SERVICE BULLETIN

Transmittal of Revision 3 to Service Bulletin V2500-ENG-72-0035

ENGINE - HP COMPRESSOR DISCS AND BLADES - STAGE-3 TO 5 - ANTI-FRET TREATMENT

V2500-A1

HP Compressor Stage-3 to 8 disc assembly - Application of dry film lubricant. Figure 2

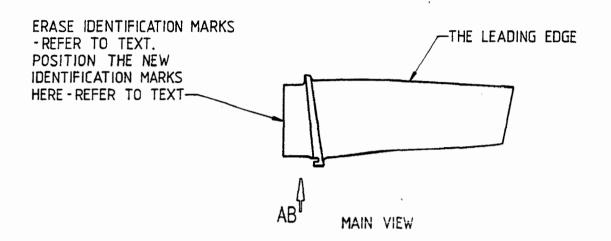
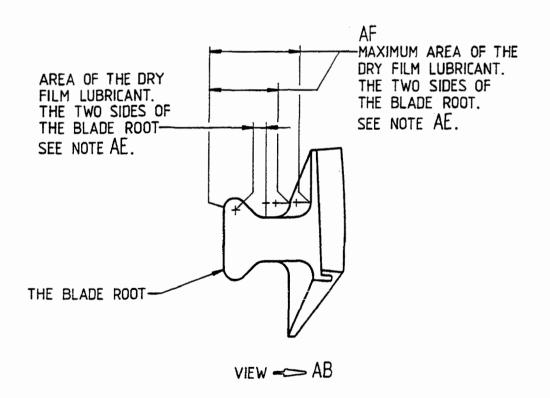
- (a) Clean the surfaces which are to be coated with the dry film lubricant. Refer to the Standard Practices Manual (SPM), TASK 70-11-01-300-503.
 - (b) With CoMat 02-002 or CoMat 02-019, mask the areas which are not to be coated with the dry film lubricant.
 - (c) Apply three layers of a correct mix of CoMat 10-002 and 07-009. Refer to the Standard Practices Manual (SPM), TASK 70-38-03-380-501, SUBTASK 70-38-03-380-002 and Figures 2 and 6.
- (d) Stove the component. Refer to the Standard Practices Manual (SPM), TASK 70-38-03-380-501, SUBTASK 70-38-03-380-005.
- R (e) Examine the layer of dry film lubricant. Refer to the Standard Practices Manual (SPM), TASK 70-38-03-380-501, SUBTASK 70-38-03-220-001

NOTE AK
APPLY 3 LAYERS OF THE DRY FILM LUBRICANT WHERE SPECIFIED TO A THICKNESS
OF 0.00012(0,003) TO 0.00059(0,015) FOR EACH LAYER - REFER TO TEXT.
THE DRY FILM LUBRICANT IS PERMITTED ON THE ADJACENT SURFACES WHERE
SPECIFIED AH TO A MAXIMUM THICKNESS OF 0.00100(0,025).
THE DRY FILM LUBRICANT IS PERMITTED ON THE ADJACENT SURFACES WHERE
SPECIFIED AJ TO A MAXIMUM THICKNESS OF 0.00180(0,045).

Rework of the Stage-3 HP Compressor Blade Figure 3

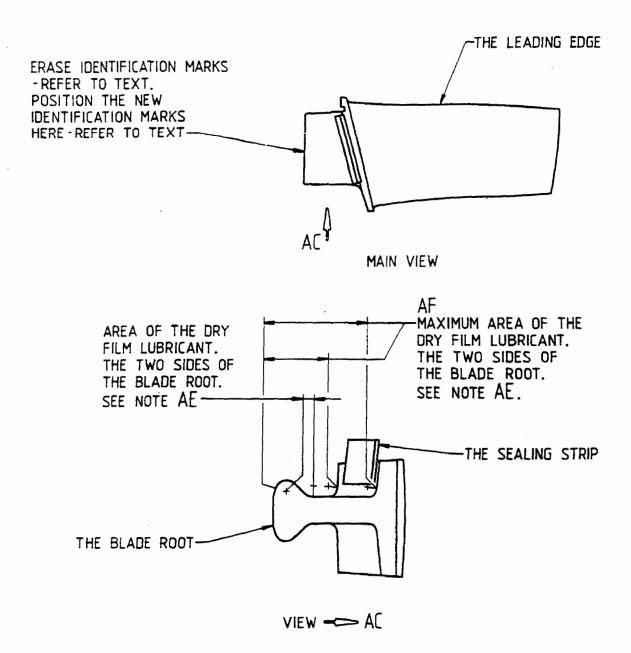
- (a) Clean the surfaces which are to be coated with the dry film lubricant. Refer to the Standard Practices Manual (SPM), TASK 70-11-01-300-503.
- (b) With CoMat 02-002 or CoMat 02-019, mask the areas which are not to be coated with the dry film lubricant.
- (c) Apply four layers of a correct mix of CoMat 10-002 and 07-009. Refer to the Standard Practices Manual (SPM), TASK 70-38-03-380-501, SUBTASK 70-38-03-380-004 and Figures 2 and 3.
- (d) Stove the component. Refer to the Standard Practices Manual (SPM), TASK 70-38-03-380-501, SUBTASK 70-38-03-380-005.
- (e) Examine the layer of dry film lubricant. Refer to the Standard Practices Manual (SPM), TASK 70-38-03-380-501, SUBTASK 70-38-03-220-001
- (f) With a vibro-engraving tool, cancel the existing part number and re-identify with the new part number.

NOTE AE
APPLY 4 LAYERS OF THE DRY FILM LUBRICANT WHERE SPECIFIED - REFER TO TEXT.
THE TOTAL THICKNESS TO BE 0.00031(0,008) TO 0.00118(0,030).
THE DRY FILM LUBRICANT IS PERMITTED ON THE ADJACENT SURFACES WHERE
SPECIFIED AF AND THE BLADE ROOT END FACES ONLY.

THE DRY FILM LUBRICANT MUST NOT TOUCH THE SEALING STRIPS (WHERE APPLICABLE).

Rework of the Stage-4 HP Compressor Blade Figure 4

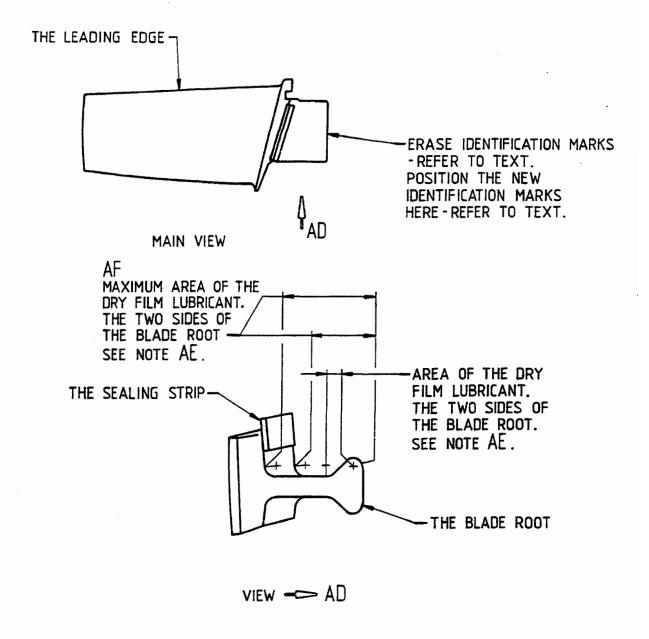
- (c) Apply four layers of a correct mix of CoMat 10-002 and 07-009. Refer to the Standard Practices Manual (SPM), TASK 70-38-03-380-501, SUBTASK 70-38-03-380-004 and Figures 2, 4 and 5.
- R (d) Stove the component. Refer to the Standard Practices Manual (SPM), R TASK 70-38-03-380-501, SUBTASK 70-38-03-380-005.
- R (e) Examine the layer of dry film lubricant. Refer to the Standard Practices Manual (SPM), TASK 70-38-03-380-501, SUBTASK 70-38-03-220-001
- R (f) Bond on the sealing strips. Refer to VRS6214 Stage-4 or VRS6215 Stage-5.
 - (f) With a vibro-engraving tool, cancel the existing part number and re-identify with the new part number.
